SUBJECT: POINT BEACH NUCLEAR PLANT, UNIT NOS. 1 AND 2 - ISSUANCE OF AMENDMENTS RE: INCREASE FUEL ENRICHMENT FOR SPENT FUEL POOL STORAGE (TAC NOS. M97837 AND M97838)

Amendment No. 179
License No. DPR-24

Amendment No. 183
License No. DPR-27

SAFETY EVALUATION BY THE OFFICE OF NUCLEAR REACTOR REGULATION

Figure 15.5.4-1

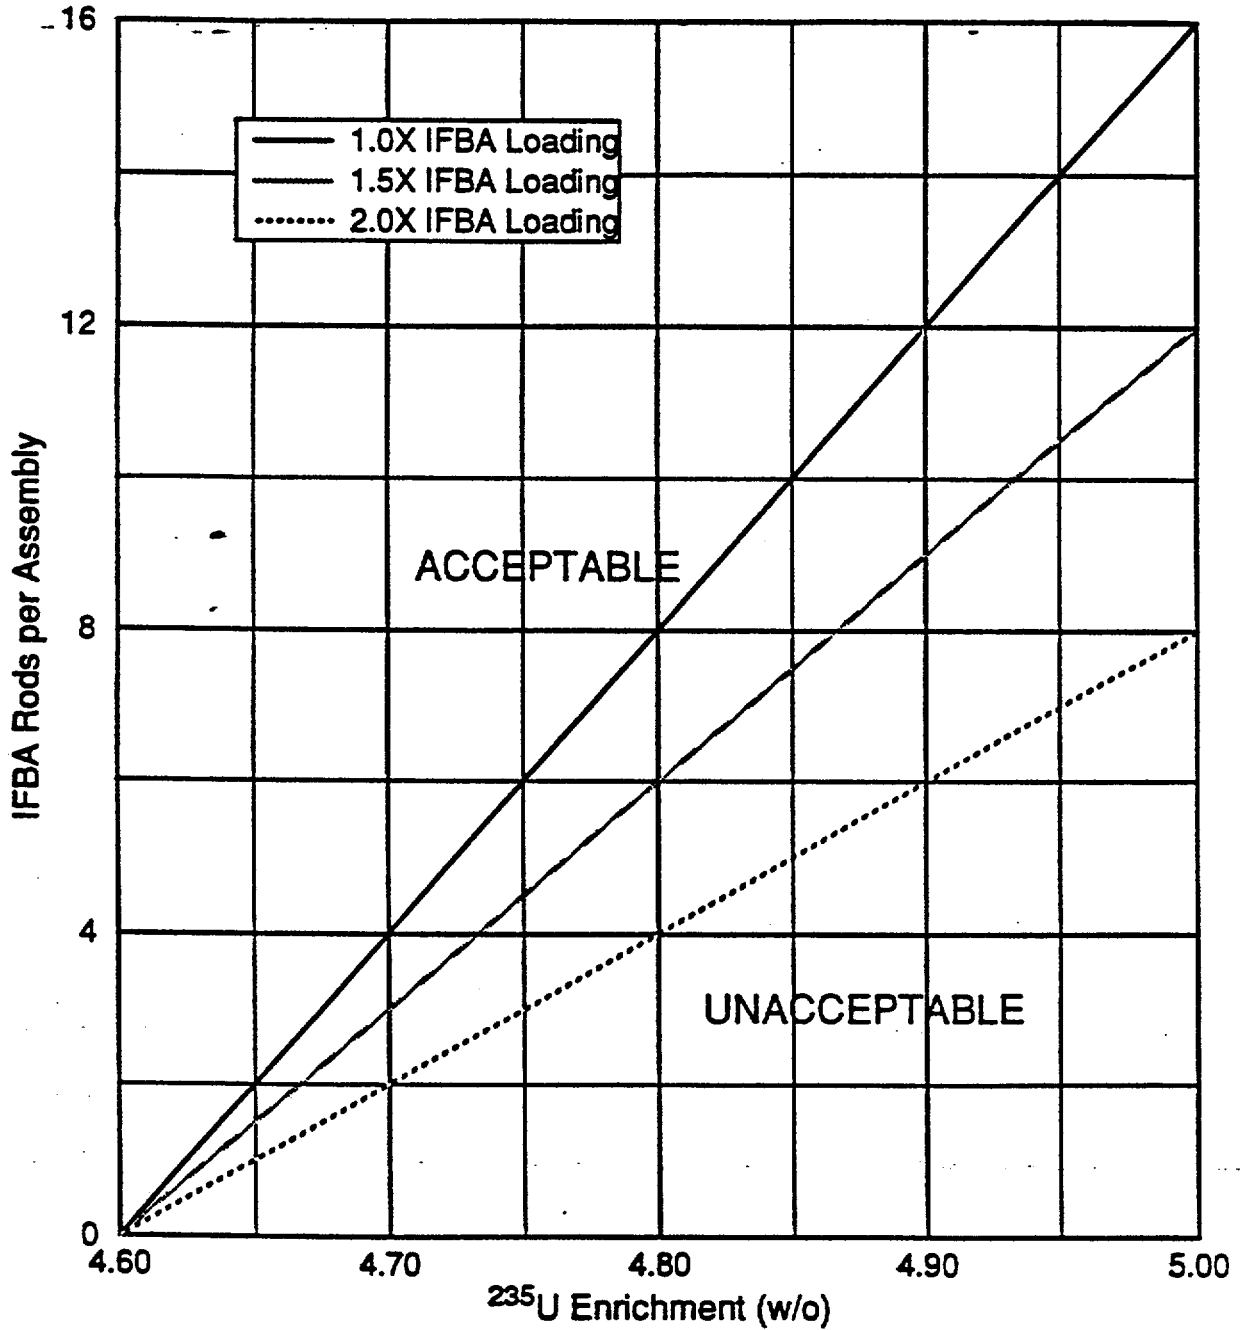
To allow the storage of fuel assemblies with nominal enrichments greater than 4.6 w/o U-235, the licensee used the concept of reactivity equivalencing. In this technique, which has been previously approved by the NRC, credit is taken for the reactivity decrease due to the IFBA material coated on the outside of the uranium dioxide pellet. Based on these calculations, the reactivity of the fuel rack array containing fuel assemblies enriched to 5.0 w/o U-235 with each containing 16 IFBA rods, was found to be equivalent to the rack reactivity with 4.6 w/o fuel with

no IFBA rods. The calculation assumed the standard IFBA patterns used by Westinghouse with the minimum standard loading of 1.675 milligram per inch of Boron-10 per rod. Since the worth of individual IFBA rods can change depending on position within the fuel assembly, additional margin was included in the IFBA requirement to account for this. In addition, the IFBA requirements also include a 10% margin on the total number of IFBA rods for 5.0 w/o enriched assemblies to account for calculational uncertainties. The staff concludes that the IFBA requirement calculations contain sufficient conservatism to account for manufacturing and calculational uncertainties.

The TS would require that assemblies with enrichments greater than 4.6 w/o U-235 incorporate IFBAs, as shown in proposed TS Figure 15.5.4-1, or have a reference k_{∞} less than or equal to 1.49364.

Fuel Assembly IFBA Requirements

Note: 1.0X, 1.5X, and 2.0X IFBA rods have nominal poison material loadings of 1.67, 2.50, and 3.34 milligrams B-10 per inch, respectively.
